MEMORANDUM

From: Service Manager Environment **To:** Head of Environment and Planning
Our Ref: EP/DC/PP/2016/0504 **Your Ref:** PF/P/2016/0504
Date: 8th June 2016

Location: O. S Grid Ref: 376 416 Land adjoining and east of Fairleigh, Station Road, Overton, Wrexham.

Development: Submission of Reserved Matters Pursuant To Outline Planning Permission Code No P/2014/0592 (Appearance, Layout, Scale And Landscaping) - Erection of 4 No. Detached Dwellings

Turning Areas

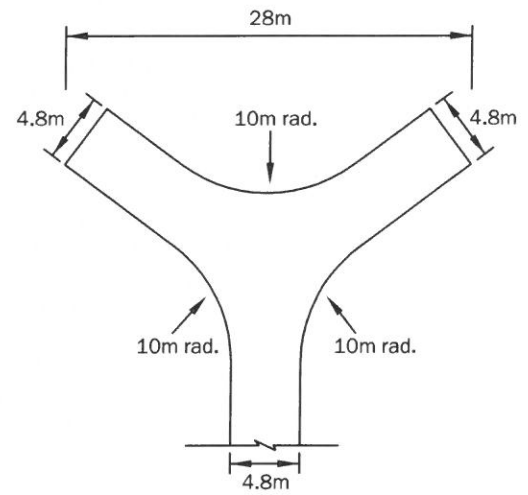
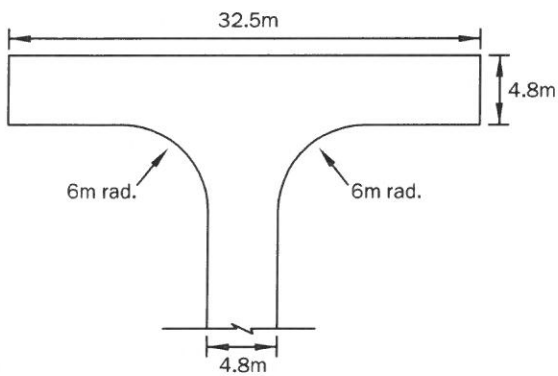
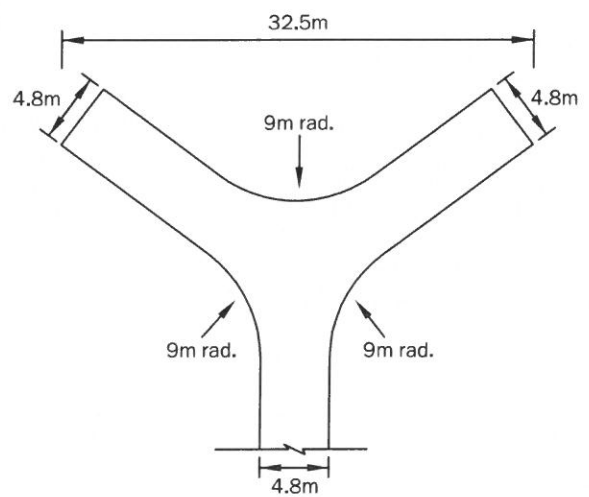
A turning head constructed to adoptable standards will need to be provided to serve the proposed development site. This will be required to facilitate the turning of refuse wagons / delivery vehicles within the curtilage of the site. A suitable turning head has not been demonstrated on the submitted layout plan. Details of a suitable turning head are attached. **Could you please ask the applicant to indicate the above detail on a revised layout plan.**
